CHANGE ORDER

CHANGE ORDER
NUMBER
1
9/9/2024
Page 1 of 2

☑ORDERED BY ENGINEER UNDER SECTION 1-04.4 OF THE	PROJECT IDENTIFICATION		
STANDARD SPECIFICATIONS.	PROJECT NAME: Southwest Recycling and Transfer Station		
☐ CHANGE PROPOSED BY CONTRACTOR	(SWRTS) Tipping Floor Resurfacing		
	PROJECT NUMBER: PW-23-006SB		
CONTRACTOR ENDORSEMENT:			
	CONTRACTOR: Concrete Restoration, Inc.		
SIGNATURE DATE	ADDRESS: 9587 8 th Ave South		
	Seattle, WA 98108		
TITLE

SHEET 3

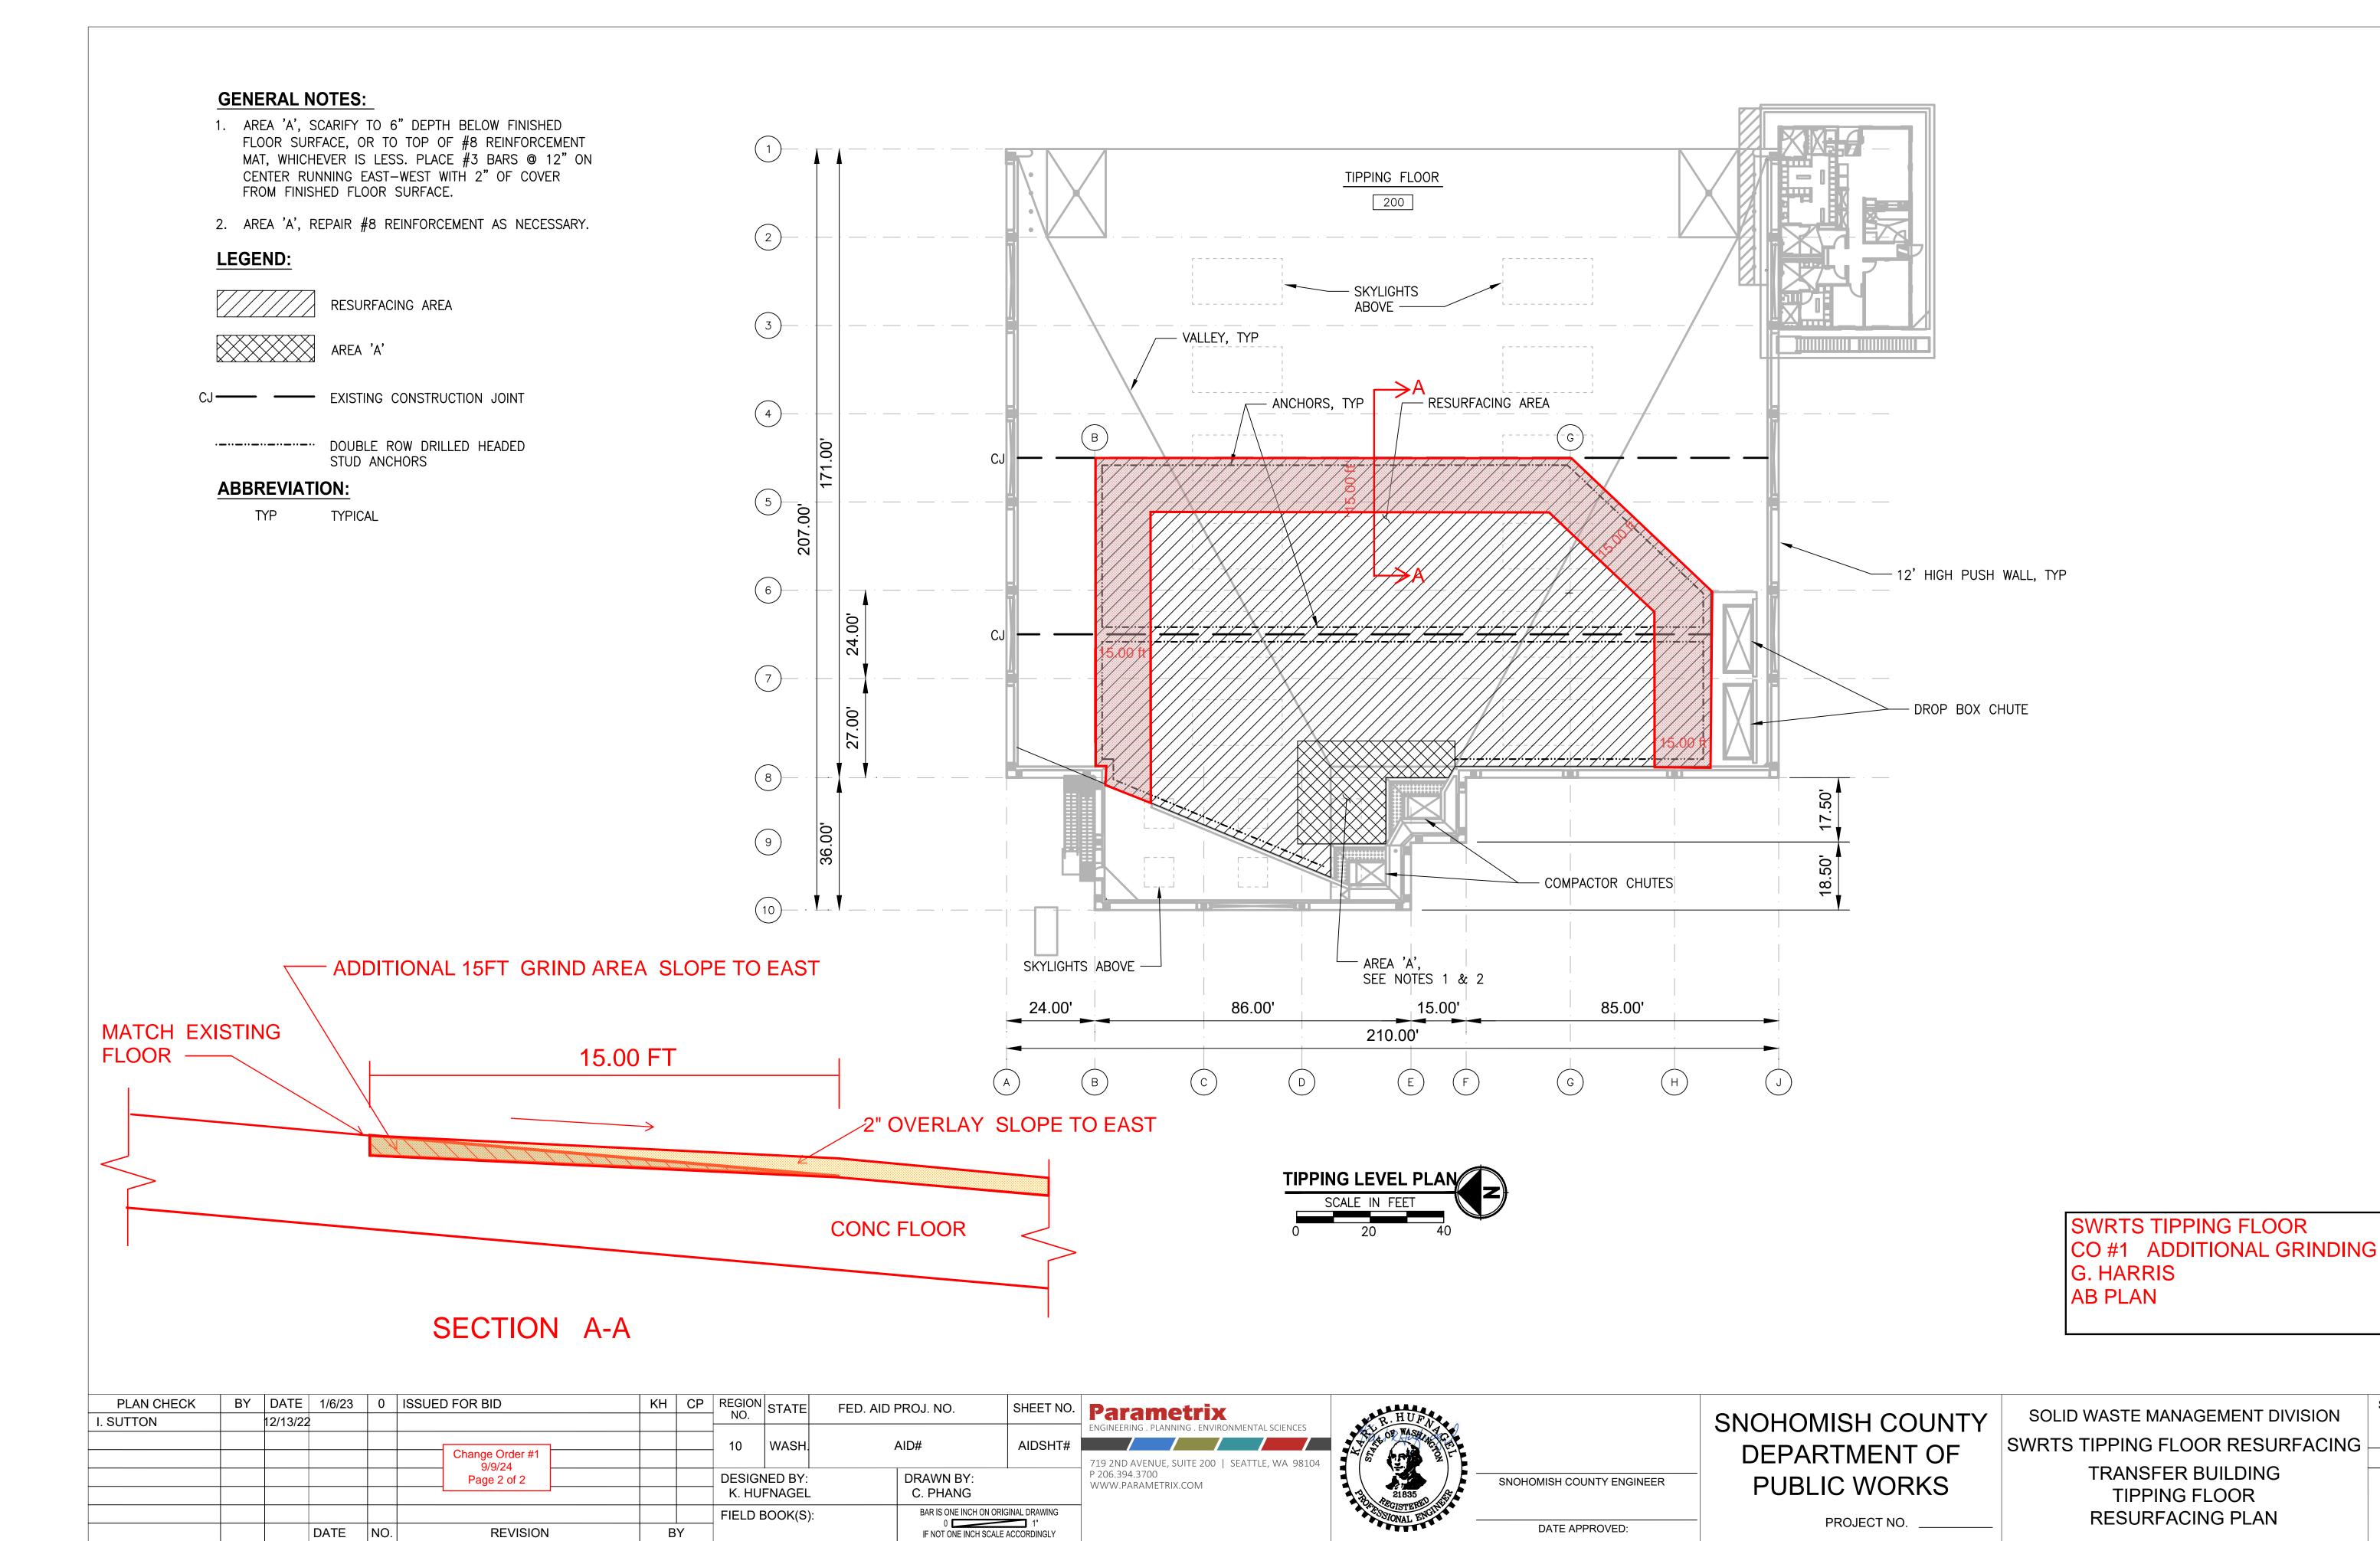
This Change Order compensates the Contractor for additional Work to grind the existing concrete tipping floor as shown on the revised SWRTS TIPPING FLOOR RESURFACING Plan Sheet 3 OF 3.

Add new item #1 "Additional Grinding" in the amount of one (1) lump sum amount.

Item #1, "Additional Grinding", shall be paid at the mutually agreed lump sum price of \$14,578.00 and shall be full compensation for all costs associated with the added Work including grinding, debris removal and disposal.
